**RAI: Volume 3, Chapter 2.2.1.3.3, First Set, Number 1:**

### 1.1 REPRESENTATIVENESS OF THE NFC MODEL STARTING WATERS

Figure 1. Range of Chloride Concentrations in Screened-in and Screened-out Water Samples

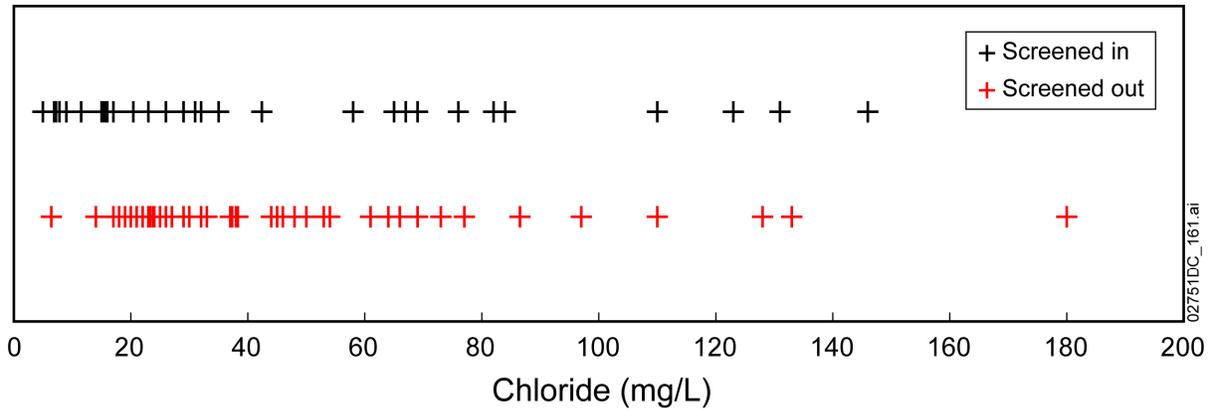
With respect to chloride concentrations, support for the representativeness of the 34 selected water compositions is provided by comparison to the other 56 pore waters that were screened out as being affected by microbial activity during core storage. The screened-out waters can be used for this because microbial activity does not affect chloride concentrations. Although these sample populations are not entirely independent (some waters in each group were collected at the same locations), similarity in the two groups would indicate that they are both representative of the same overall population, and provide support that the population is adequately represented. The 56 waters represent more sampling sites than the 34 waters that were screened in, because they include sample sites along more than 2 km of the Enhanced Characterization of the Repository Block Cross-Drift. The chloride concentration range of the screened-in waters bounds that of the screened-out waters, except for two samples, both with chloride concentrations of 180 mg/L (Figure 1). Cumulative distribution functions for the two data sets are provided in Figure 2. The distributions have nearly identical means and standard deviations. When evaluated using the Wilcoxon Rank Sum Test, a p-value of 0.468 (47%) is calculated. This value represents the probability of incorrectly rejecting the hypothesis that the two sample groups represent the same population; the large value (5% is commonly used as a cutoff) does not indicate that the two samples represent the same population, but rather that they are

similar enough that it is not possible to conclude that they do not. Therefore, the screened-out pore-water samples provide additional confidence that the 34 screened-in samples are representative of the range of chloride concentrations at the site.

Figure 3. Range of Values in Screened-in TSw Pore Waters

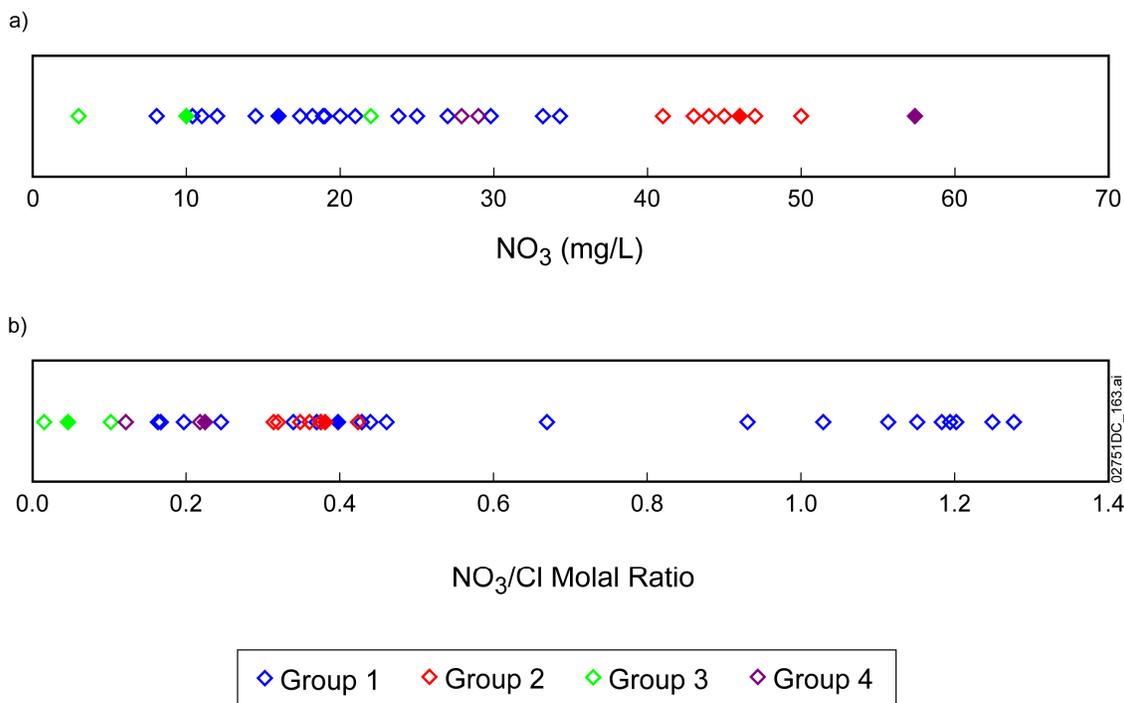
- (b) Support for the range of initial water compositions for conservative anions, such as chloride ( $\text{Cl}^-$ ) and nitrate ( $\text{NO}_3^-$ ) that are important to corrosion.

The range of nitrate concentrations in the screened-in pore waters is presented in Figure 3(a), and the range of nitrate-to-chloride ratios, in Figure 3(b). Unlike chloride, the screened-out pore-water analyses cannot be used to evaluate the nitrate concentrations in 34 selected waters because most of the screened-out pore waters were affected by microbial activity during core storage, resulting in denitrification (see the response to RAI: 3.2.2.1.3.3-003). The chloride data suggest that the effects of varying evapotranspiration are captured in the range of waters used. The Yucca Mountain soils are relatively thin and vegetation sparse or absent, contributing to the measured unsaturated zone gases containing atmospheric levels of oxygen. Consequently, it is unlikely that any area exists within the repository foot print where soil conditions are reducing and complete depletion of nitrate occurs. The absence of strong reducing environments supports the conclusion that the range of nitrate concentrations is representative or at least bounding.

Figure 4. Evaporative Evolution of the 34 TSw Pore Waters Used in the NFC Model ( $p\text{CO}_2 = 10^{-3}$  bars;  $T = 25^\circ\text{C}$ )

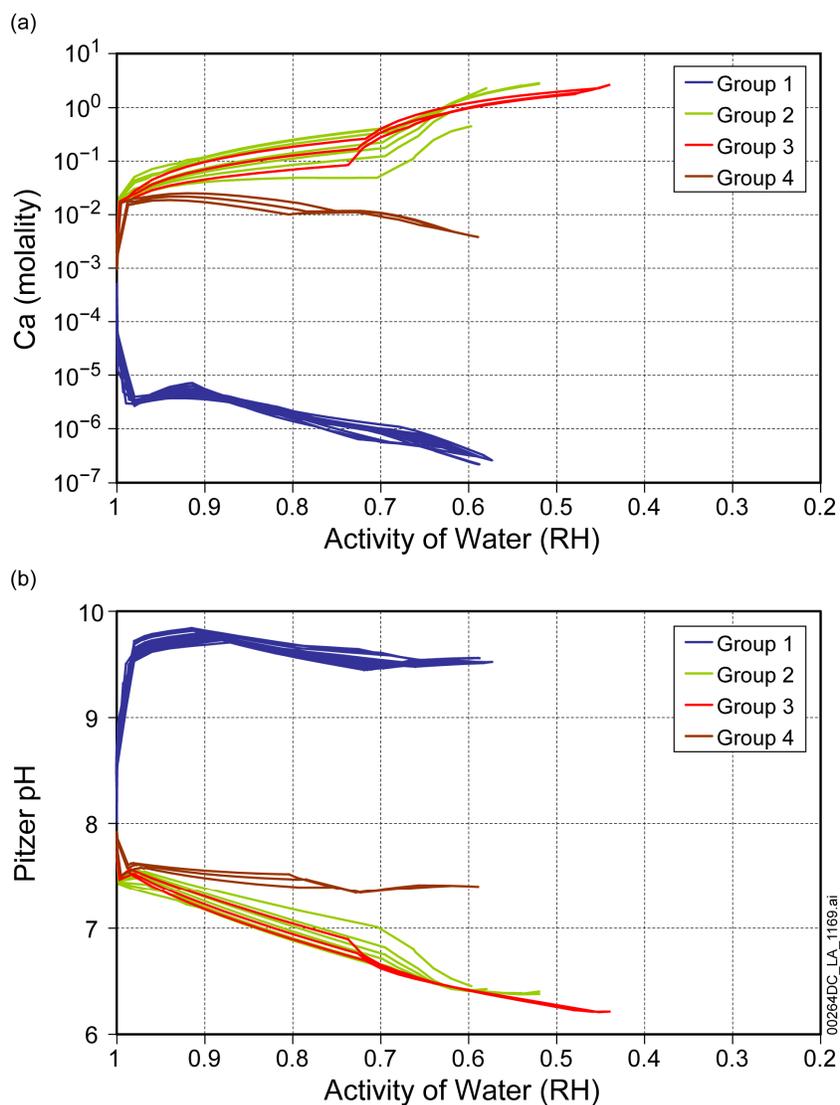
- (d) An explanation of uncertainty and its propagation in the near-field chemistry model and performance assessment model. Also address the likely process-level causes for the bimodal distribution of the 34 sample compositions that passed the quality screening criteria (SAR Figure 2.3.5-9).

To explain how these waters are used and how uncertainty in initial water compositions is propagated through to the TSPA-LA model, it is necessary to explain how the NFC model couples with the seepage evaporation abstraction and with the TSPA-LA model (SAR Sections 2.3.5.3.4 and 2.3.5.5.4). This is illustrated in a flow chart in Figure 5. The four waters identified in Table 1 are used as the starting waters in the NFC model. Because TSPA calculations do not use seepage water compositions (representing seepage before it enters the drift) directly, but rather calculate in-drift water compositions, these four starting waters are not used to calculate a time history of seepage compositions. Instead, the four waters are used to parametrically generate a set of seepage water compositions, in the form of EQ3/6 pickup files, at 11 discrete water–rock interaction parameter (WRIP) values (amounts of feldspar dissolved), and at three different temperatures (30°C, 70°C, and 96°C) for use as initial water compositions by the in-drift seepage evaporation abstraction. There are a total of 132 pickup files (11 × 4 × 3 = 132). The seepage evaporation abstraction in turn generates 396 lookup tables by simulating evaporation of the 132 seepage water compositions at *p*CO<sub>2</sub> values of 10<sup>-2</sup>, 10<sup>-3</sup>, and 10<sup>-4</sup> bars; the temperatures used are the same as those used in the NFC model calculations, except 100°C is used instead of 96°C. The seepage evaporation abstraction lookup tables provide potential in-drift water compositions as a function of relative humidity. Each lookup table is identified by four parameters—the initial group water (4), the WRIP value (11), the temperature (3), and the in-drift *p*CO<sub>2</sub> (3).

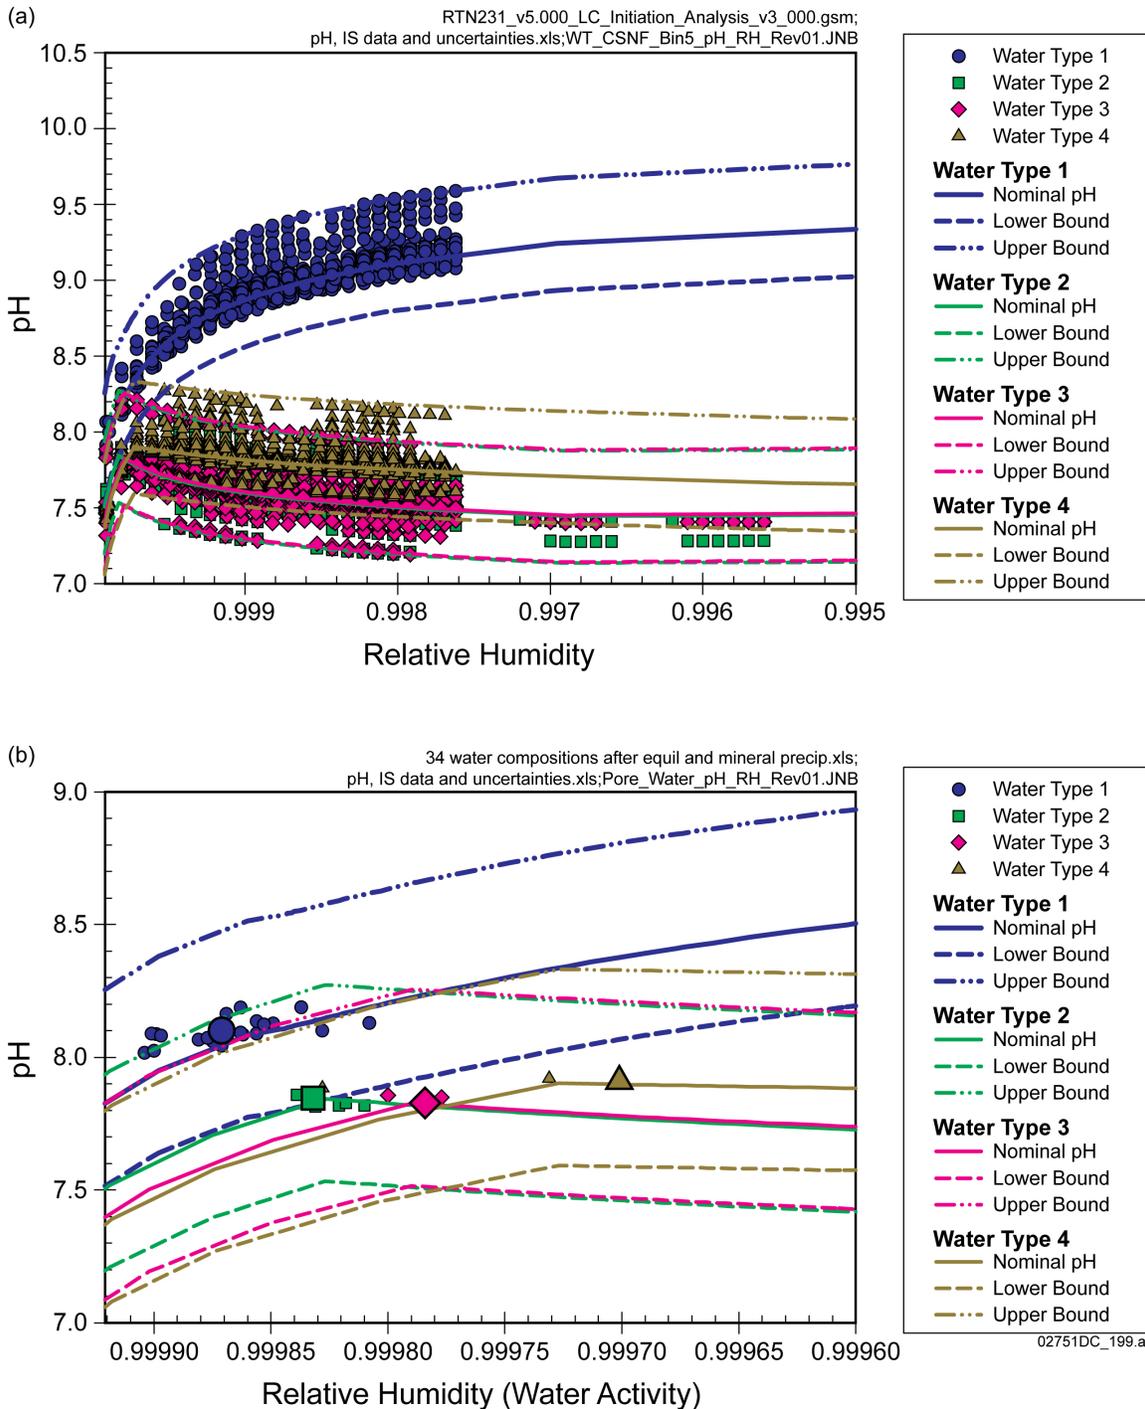
Provide the following additional technical bases to demonstrate that the near-field chemistry (NFC) model adequately calculates a range of water compositions in the natural system:

Figure 2(a) shows predicted pH conditions at the surface of commercial spent nuclear fuel (SNF) waste packages in Percolation Subregion 5 as a function of relative humidity (RH) at  $t = 1,000,000$  years given by the localized corrosion initiation analysis for the TSPA. Small changes in relative humidity result in large changes in evaporative concentration, so a large range of pH values is predicted. Figure 2(b) plots the pH of the 34 pore waters as a function of relative humidity, which is equal to the activity of water in the pore-water solutions. At relative humidity values higher than that representing equilibrium with the starting waters, the water compositions are diluted relative to the starting waters; pH values in this relative humidity range evolve to lower values, towards pure water in equilibrium with a  $p\text{CO}_2$  of  $10^{-3}$  bars. At relative humidities lower than that representing equilibrium with the initial pore waters, the waters are evaporatively concentrated, and the trends in pH vary with the starting water. The pH values for Group 1 water increase significantly with minor decreases in relative humidity, while for Group 2, 3, and 4 waters, pH decreases slightly relative to the starting waters. Overall, the pH range is approximately 7.4 to 9.6 at ambient conditions. (Note that on Figure 2 and on following plots, water “types” are equivalent to water “groups.”)

Figure 8. Thermochronologic Data from Fracture Minerals in the Topopah Spring Tuff

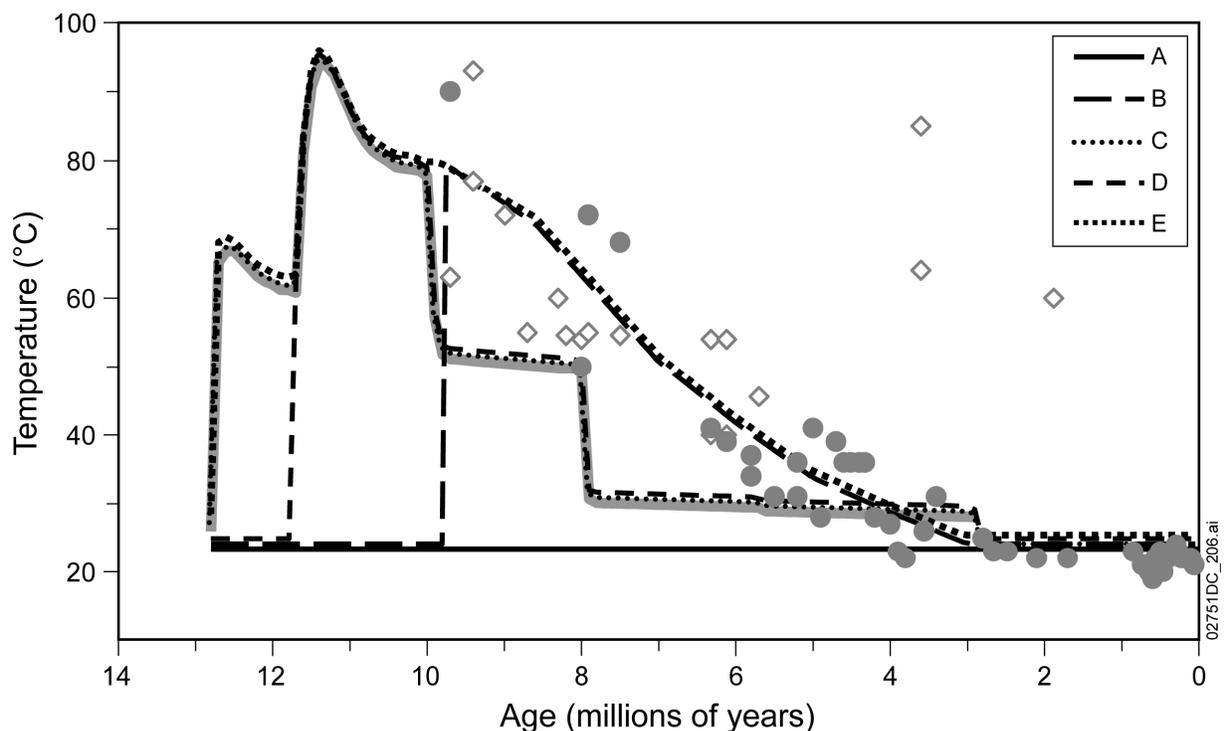
The basis of the RAI suggests that the ambient feldspar dissolution rate and  $E_a$  used by the THC seepage model might constitute an alternative conceptual model. The following discussion describes why the treatment of these parameters in the NFC model is more appropriate for application in the TSPA.

Because the NFC model feldspar dissolution rate is calibrated to the thermal history of the tuff using a specific  $E_a$ , the parameters cannot co-vary (see the response to RAI: 3.2.2.1.3.3-004). The same extent of alteration would be calculated using a faster alteration rate and a lower  $E_a$ , or a slower rate and a higher  $E_a$ . To further support the estimated range used for the NFC model, this response presents a new calculation that is similar to, but more detailed than, the calculation used in the model report to calculate the uncertainty in the feldspar dissolution rate (SNL 2007a, Section 6.12.2). In this approach, specific thermal histories for the tuff are developed and subdivided into time steps, for calculating the cumulative amount of feldspar dissolved, to compare with the accumulated abundance of secondary aluminosilicates (approximately 3.4% of the original feldspar has dissolved; SNL 2007a, Table 4.1-9 and Section 6.3.2.4.2). The calculation is repeated for different ambient feldspar dissolution rates and  $E_a$  values, and for several candidate thermal histories which are based on thermochronologic measurements on fracture minerals from Yucca Mountain (Figure 8), and on modeled thermal histories developed for the TSw tuff by the U.S. Geological Survey (USGS). The following possible thermal histories were used in the calculations (Figure 9):

Figure 1. Piper Plot for Compositions of Perched Water and Pore-Water Samples from Table 1

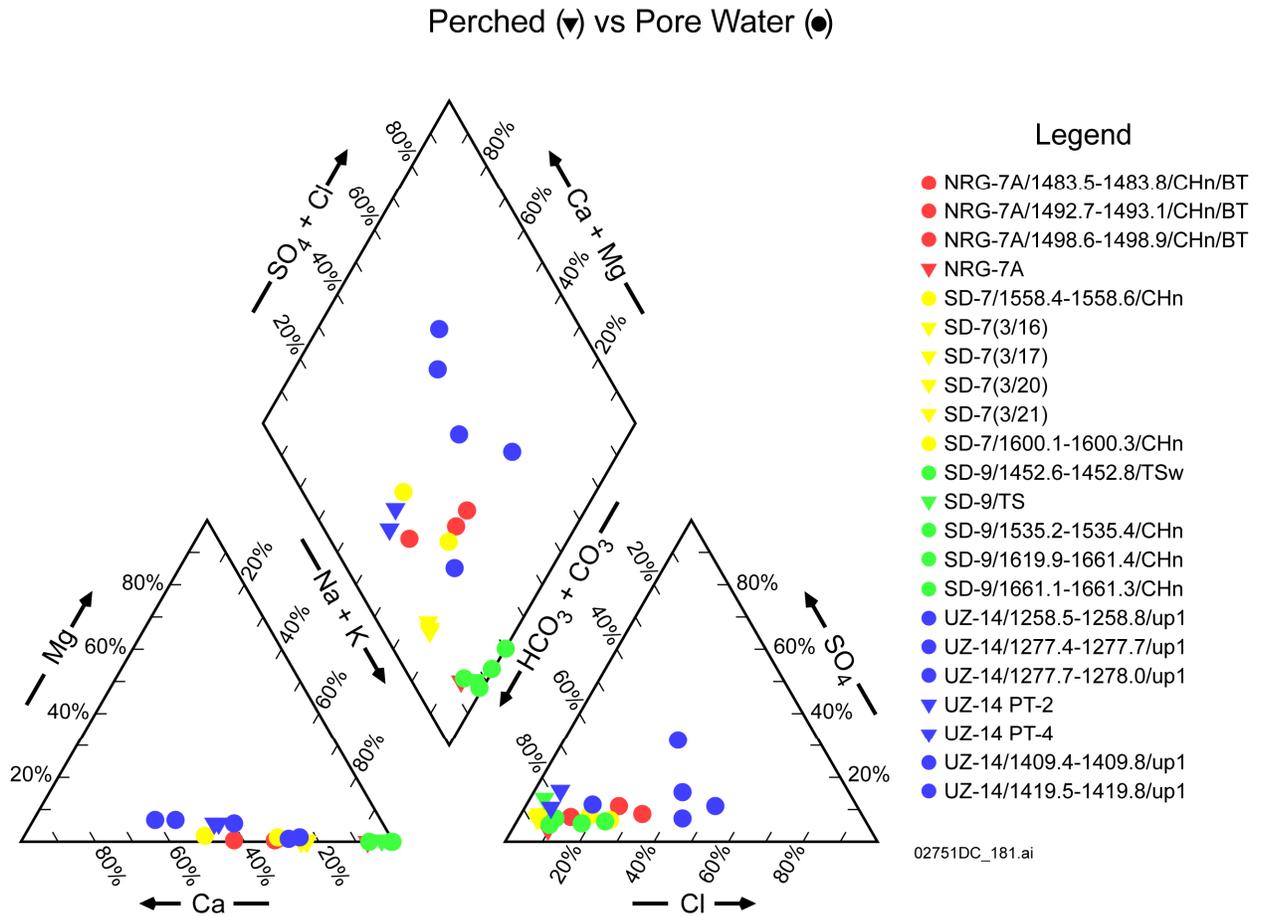
The NFC model assumes chemical equilibrium between fracture and matrix waters. Fast flow-path fracture flow may cause chemical disequilibrium between fracture and matrix waters; thus the NFC model may not adequately represent the potential range of seepage water composition. Provide additional technical bases supporting the assumption that fracture and matrix waters are in chemical equilibrium. Demonstrate that seepage water compositions calculated using the NFC model adequately represent the potential range of seepage water chemistry.

Pore waters from core samples originating above and below perched water bodies have chemical characteristics (particularly the range of chloride concentrations) that are more similar to one another than to perched waters (Figure 1). The chloride content of perched waters is so low that it overlaps that of precipitation. Given the presence of old chloride-containing soils, such low

chloride concentrations cannot be preserved by net infiltration that occurs over most of the Yucca Mountain site. This indicates that the perched waters were recharged during colder climates, along isolated, fast pathways. An alternative explanation is that perched waters, being similar to saturated zone water, may have originated from higher water tables and/or lateral flow from the north where the groundwater table is at a higher elevation. For either explanation of origin, pore water and perched water have distinctly different geochemical evolution and have undergone different degrees of evaporation, water-rock interaction, or both (SAR Section 2.3.2.3.4.1). Thus comparisons between perched and pore-water compositions cannot be used to evaluate model predictions of fracture-matrix interaction in the unsaturated host rock.
